BACnet Errata
ANSI/ASHRAE STANDARD 135-2016
A Data Communication Protocol for Building Automation and Control Networks

June 23, 2018

This document lists all known *errata* to ANSI/ASHRAE Standard 135-2016 as of the above date. Each entry is cited first by clause, then page number, except where an erratum covers more than one clause. The back page marking identifying the electronic publication of Standard 135-2016 is “Product code: D-86451 6/16”.

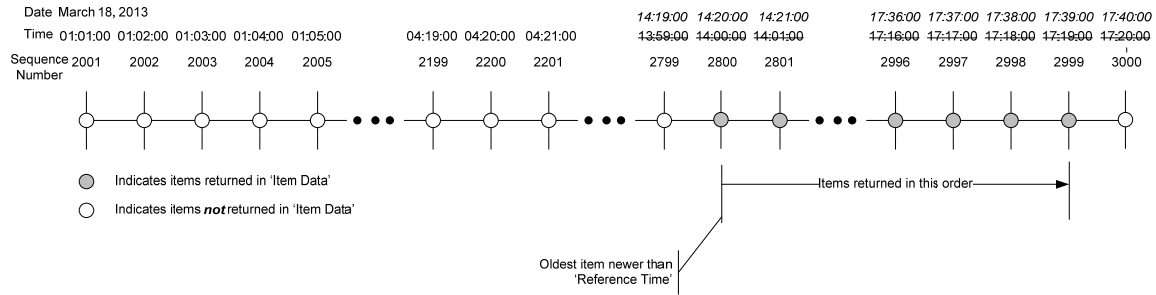
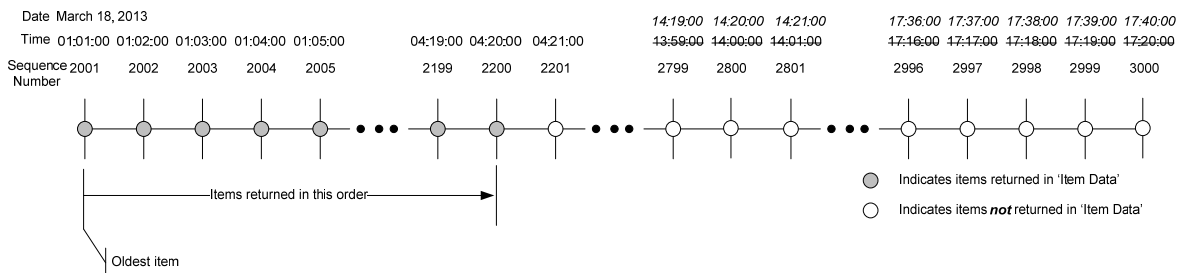
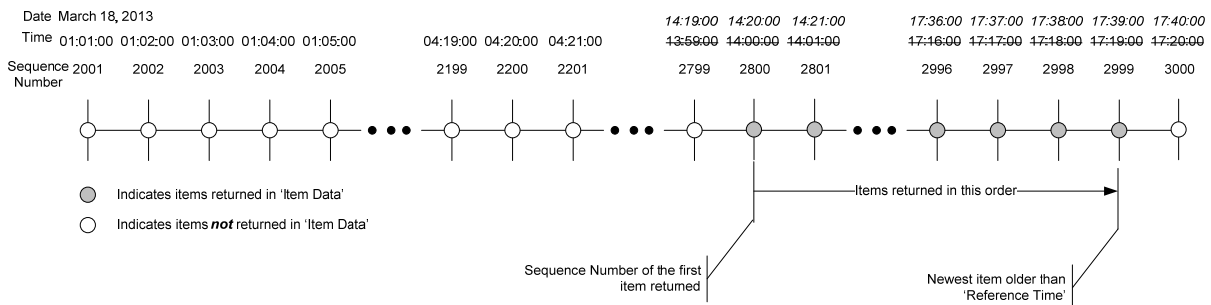
37) **Clauses 15.8.1.1.4.3.3, 15.8.1.1.4.3.4, 15.8.1.1.4.3.5**, p. 695, 696: The time scale in the examples is erroneous.

Assume a device contains a list with 1000 items and is capable of returning 200 items in a ReadRange response. The ReadRange service request contains a 'Reference Time' = March 18, 2013, ~~13:59:00~~ *14:19:00* and 'Count' = 300. The

resulting ReadRange service response contains 200 items from March 18, 2013, ~~14:00:00~~ 14:20:00 to March 18, 2013, ~~17:19:00~~ 17:39:00 with FIRST_ITEM = FALSE, LAST_ITEM = FALSE, and MORE_ITEMS = TRUE. The 'First Sequence Number' = 2800.
